Halton Borough Council Local Plan Site Screening

**Level 2 Strategic Flood Risk
Assessment – Site SL-0088 Screening**

Draft Report

1 SL-0088

Figure 1-1: Flood Zone Mapping with flood defences and ABDs

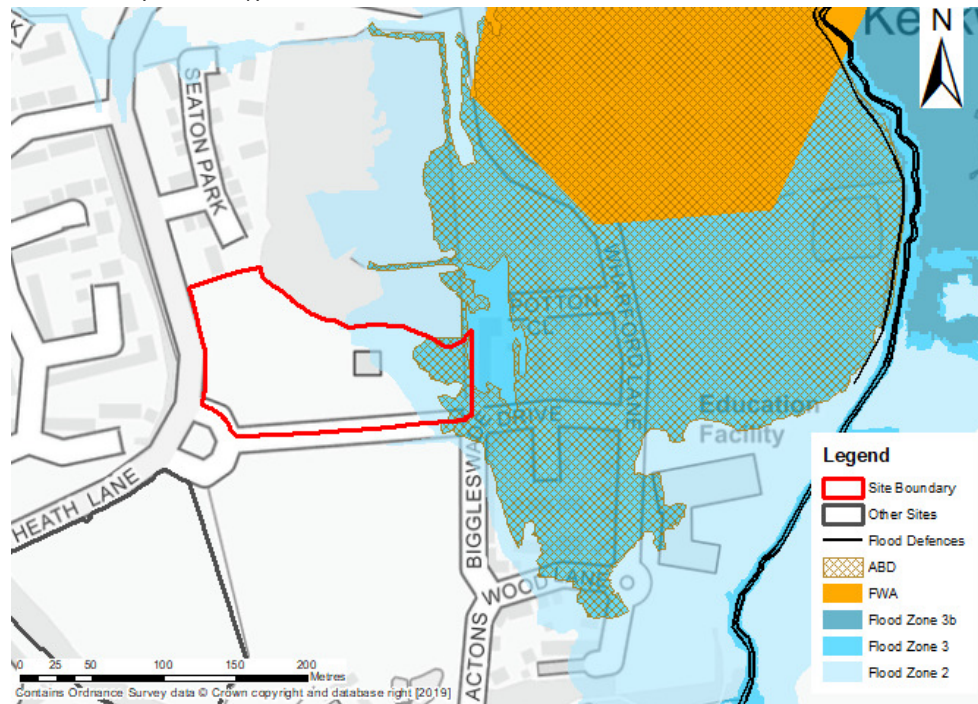
- According to the Flood Map for Planning, 9% of the site is located within Flood Zone 3a, this includes an ABD (see Figure 1-1). The ABD should cover all of Flood Zone 3, however there is a hole in it to the east of the site boundary. Require clarification from the EA as to why this is the case. Possibly related to the flood zone discrepancy.

Commented [MW2]: EA clarification required

Figure 1-3: Flood Zone discrepancy (blue = Flood Zone 3; orange = 1% AEP undefended event outline from Keckwick Brook model)

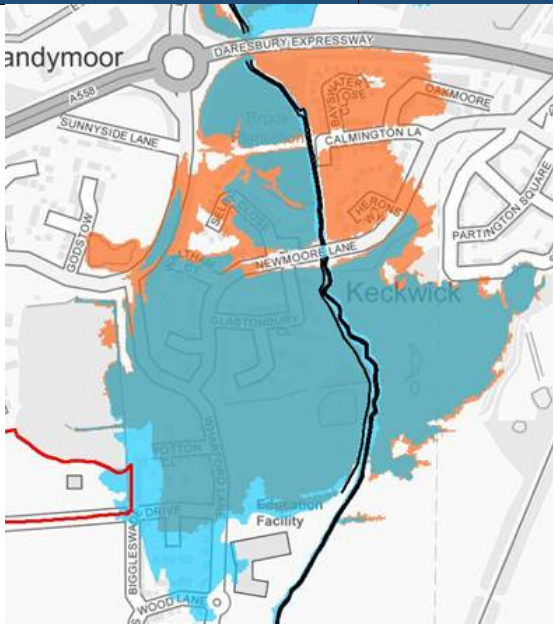
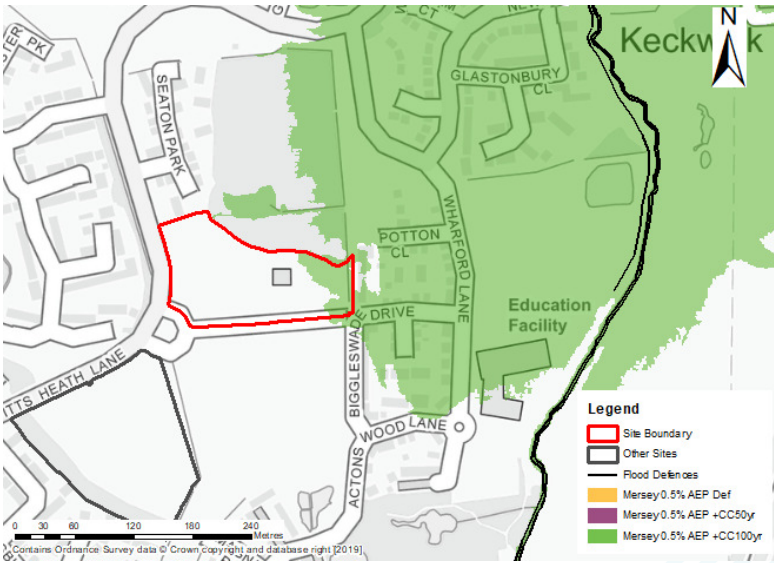
- There are discrepancies between the EA Flood Map and the modelled data for Keckwick Brook. Flood Zone 3 should be the same as the 1% AEP undefended flood outline from the Keckwick Brook model. Figure 1-3 below shows the discrepancy where blue is Flood Zone 3 and orange is the 1% undefended outline from the model. In terms of site development, it is important to know why this discrepancy exists as Flood Zone 3 is shown to enter the eastern area of the site whereas the modelling shows this is not the case. It may be that the EA has not yet updated the Flood Map with the outputs from the Keckwick Brook modelling. Before making any recommendations with regards to fluvial risk and future development at the site, we require clarification from the EA.

Commented [MW1]: Clarification required from EA

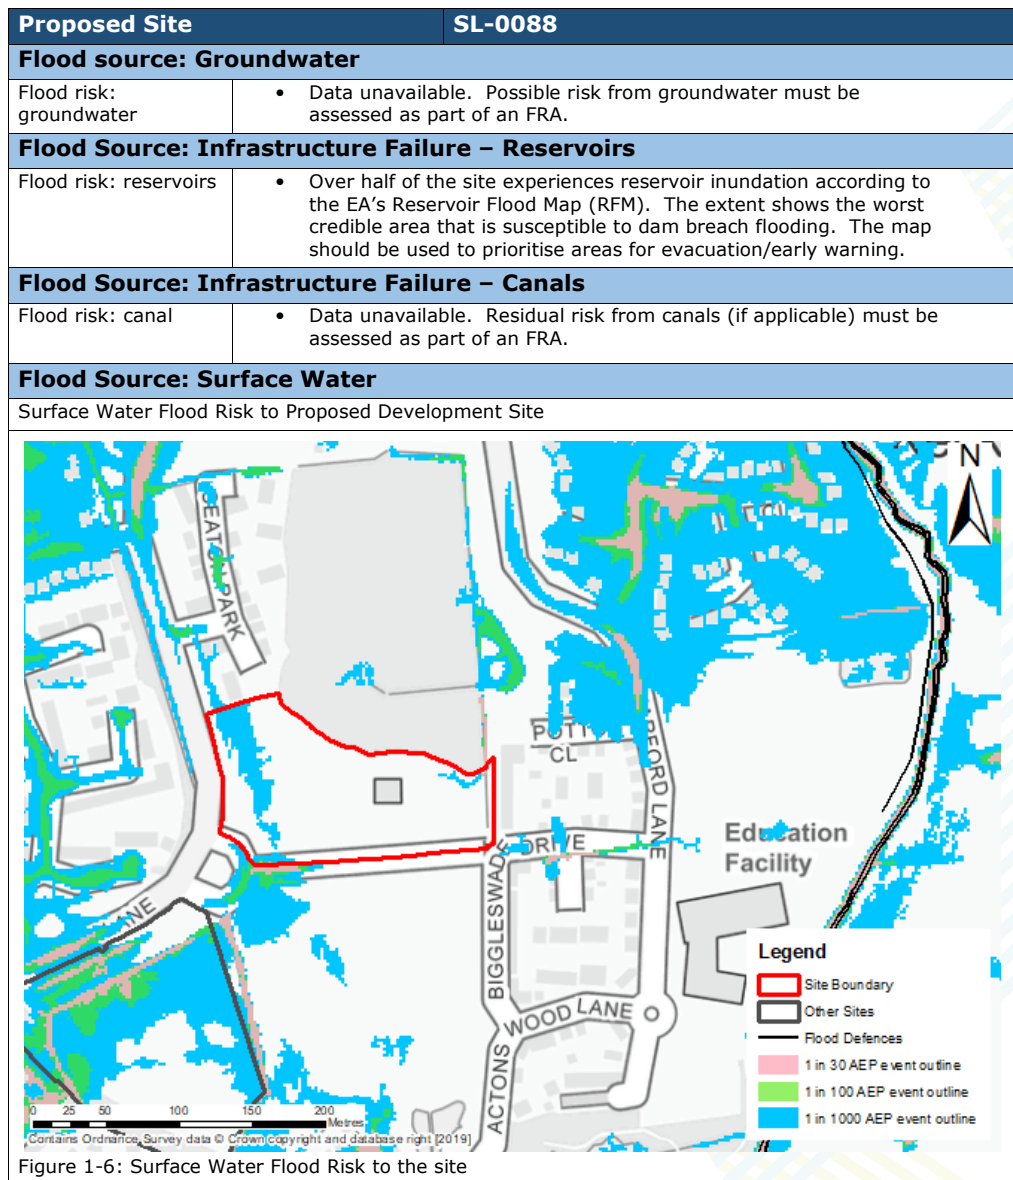
Commented [MW3]: If this is defended, how come the ABD covers the whole area? Should this figure therefore show zero flooding for the 1% defended event?

Commented [HB4R3]: I'm unsure how to answer this

Commented [JP5R3]: I've checked outlines and model files, they are correct, unsure on ABD query, follow up with EA. Especially when FZs show site at fluvial risk

Commented [MW6R3]: Does the fluvial undefended match FZ3? If not then the most likely issues is the Flood Map hasn't been updated...
